SUBJECT: ISSUANCE OF AMENDMENT NO. 154 TO FACILITY OPERATING LICENSE
NO. DPR-51 - ARKANSAS NUCLEAR ONE, UNIT NO. 1 (TAC NO. 77665)

ARKANSAS NUCLEAR ONE, UNIT NO. 1

Amendment No. 154
License No. DPR-51

SAFETY EVALUATION BY THE OFFICE OF NUCLEAR REACTOR REGULATION

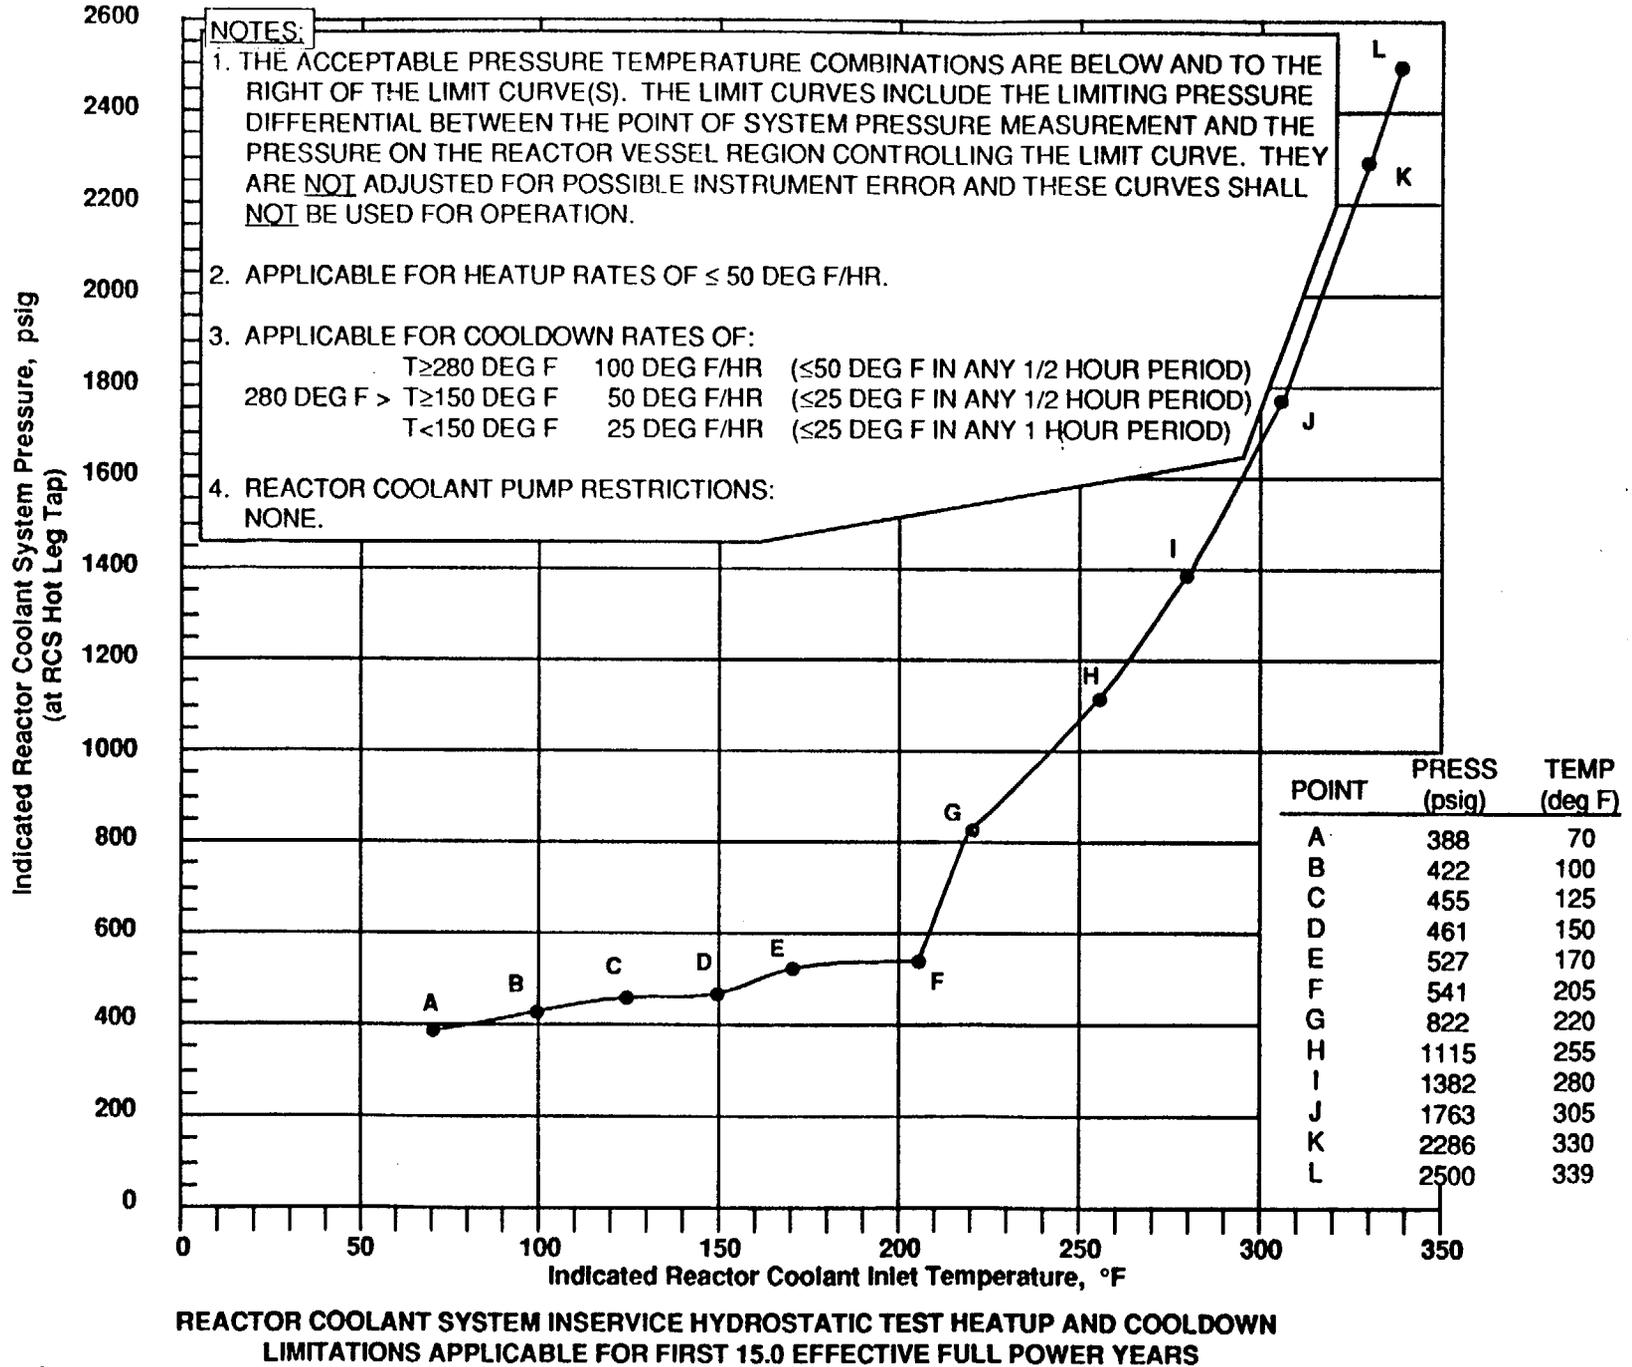
For thermal steady state system hydro tests, the system may be pressurized to the limits set forth in Specification 2.2 when there are fuel assemblies in the core, under the provisions of 3.1.2.3, and to ASME Code limits when no fuel assemblies are present provided the reactor coolant system limits are to the right of and below the limit line in Figure 3.1.2-1. The provisions of Specifications 3.0.3 and 3.0.4 are not applicable.

Figures 3.1.2-1, 3.1.2-2, and 3.1.2-3 present the pressure-temperature limit curves for hydrostatic test, normal heatup, and normal cooldown respectively. The limit curves are applicable through the fifteenth effective full power year of operation. The pressure limit is adjusted for the pressure differential between the point of system pressure measurement and the limiting component for all operating reactor coolant pump combinations.

The pressure-temperature limit lines shown on Figure 3.1.2-2 for reactor criticality and on Figure 3.1.2-1 for hydrostatic testing have been provided to assure compliance with the minimum temperature requirements of Appendix G to 10CFR50 for reactor criticality and for inservice hydrostatic testing.

Figure 3.1.2-2

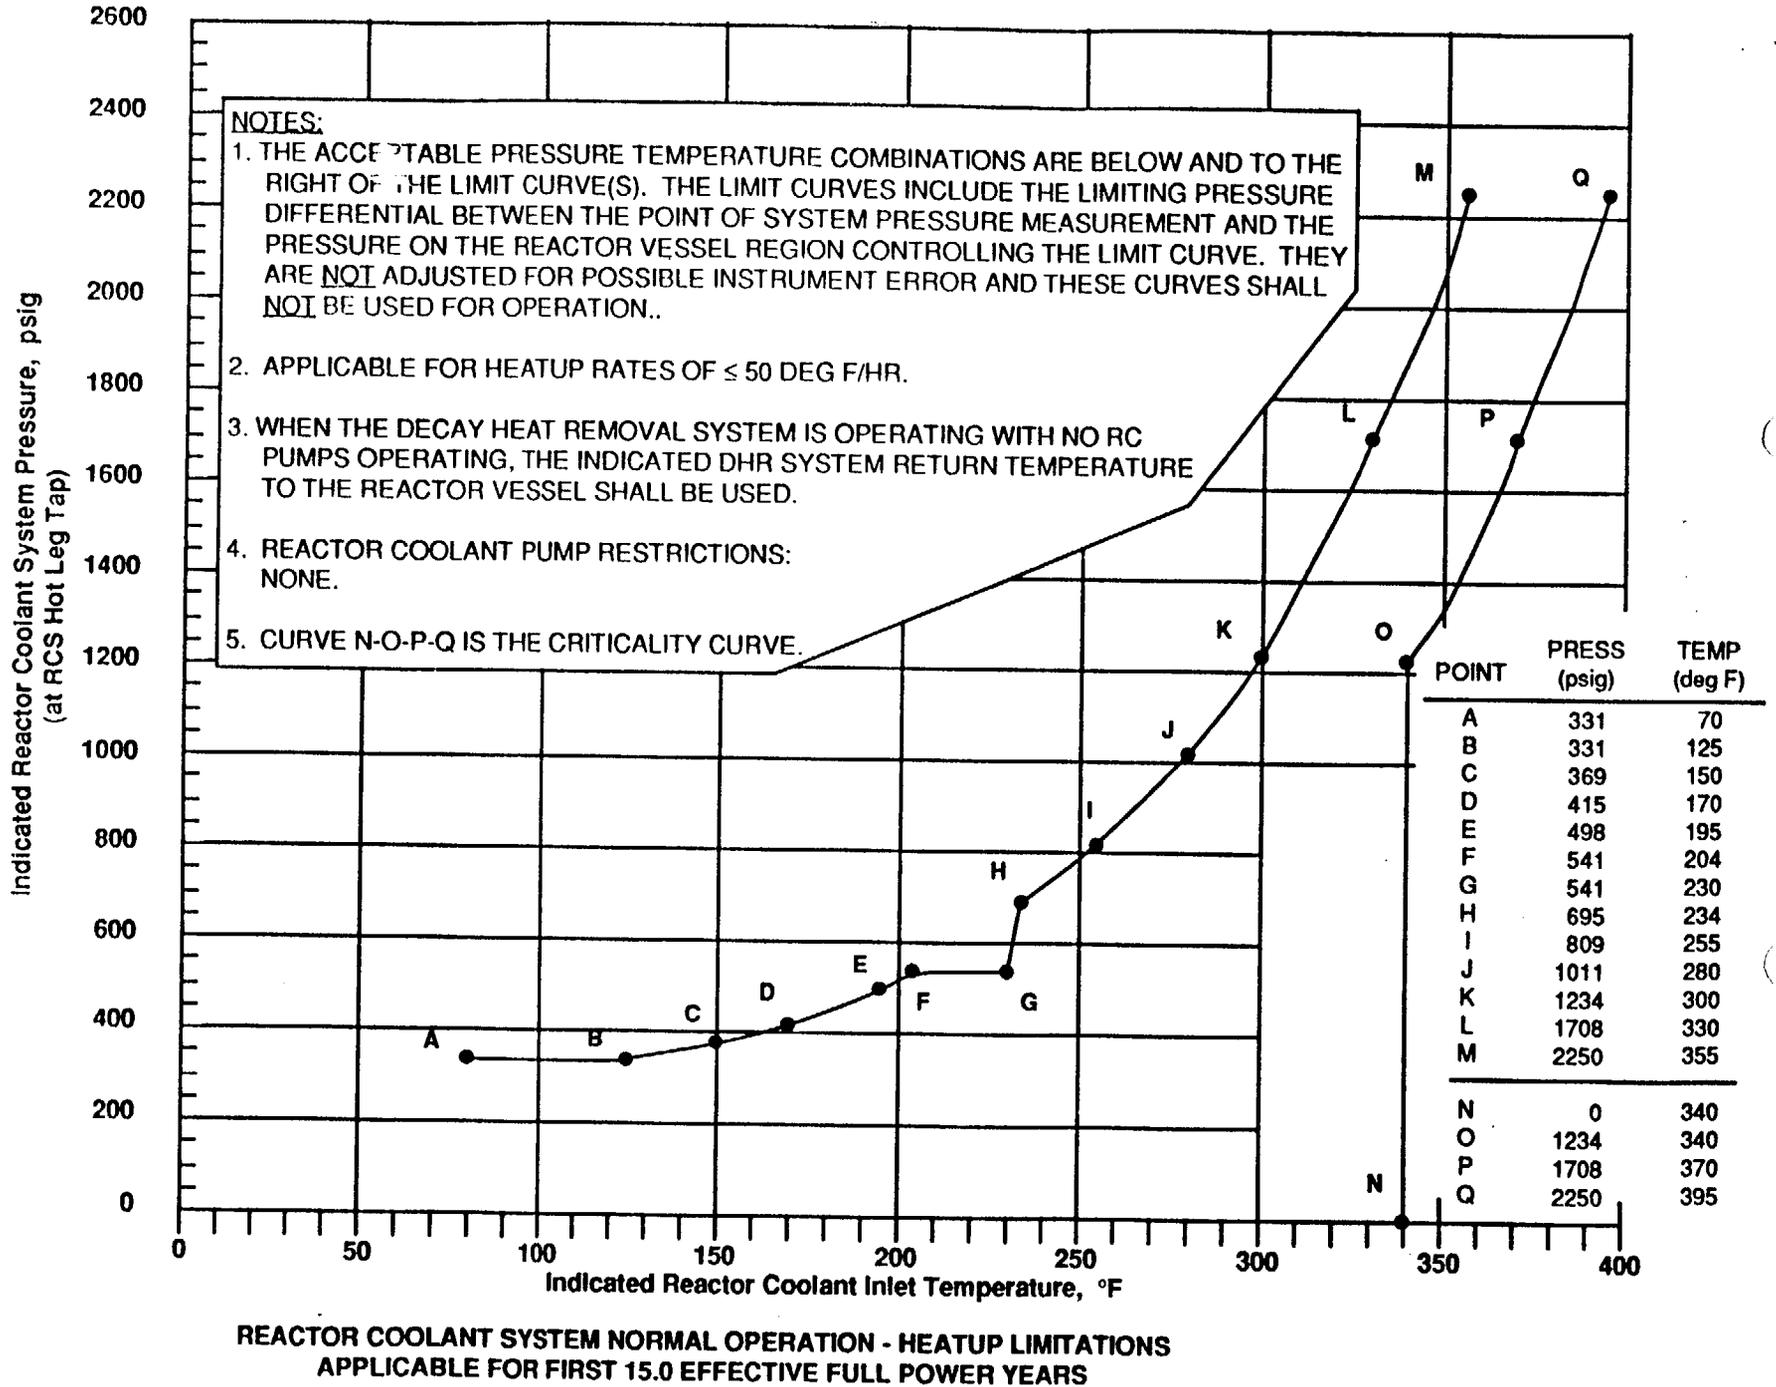
Allowable combinations of pressure and temperature shall be to the right of and below the limit line in Figure 3.1.2-2. The heatup rates shall not exceed those shown in Figure 3.1.2-2.

**REACTOR COOLANT SYSTEM NORMAL OPERATION - COOLDOWN LIMITATIONS
APPLICABLE FOR FIRST 15.0 EFFECTIVE FULL POWER YEARS**

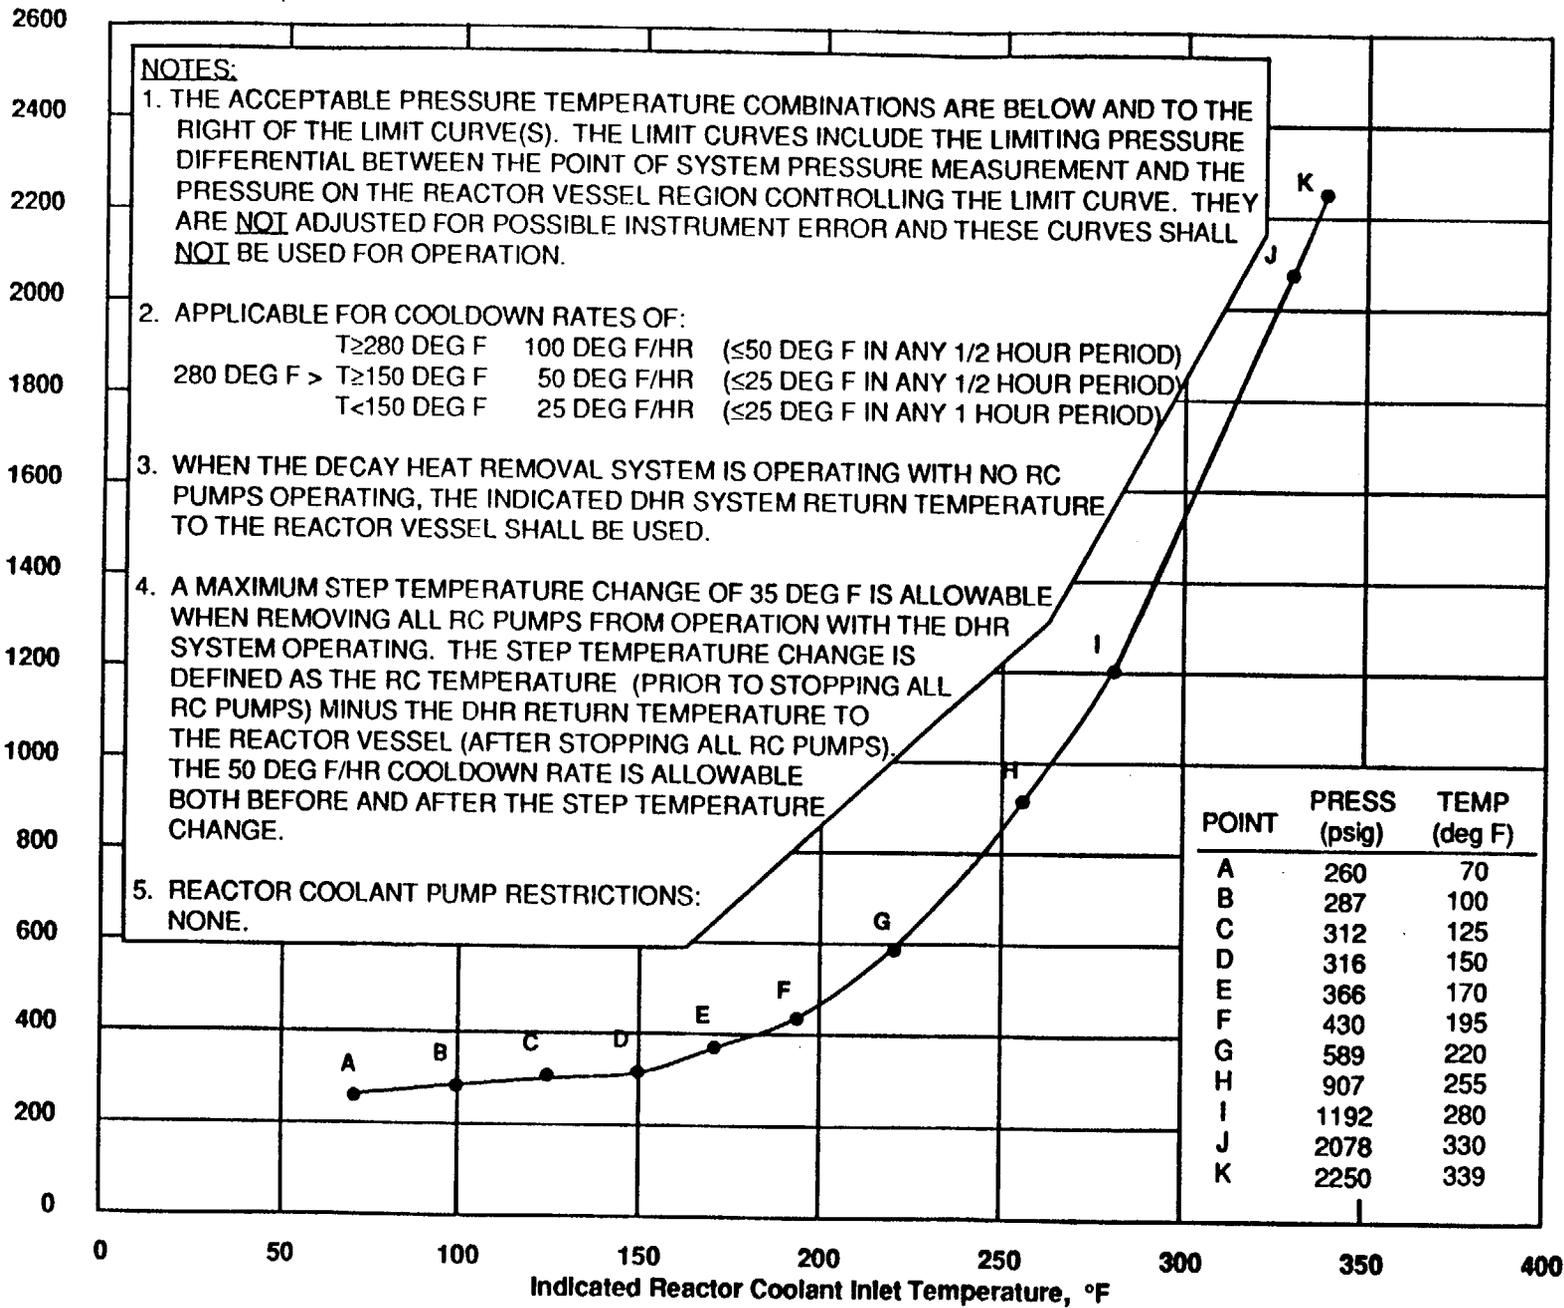
Allowable combinations of pressure and temperature for a specific cooldown shall be to the right of and below the limit line in Figure 3.1.2-3. Cooldown rates shall not exceed those shown in Figure 3.1.2-3.
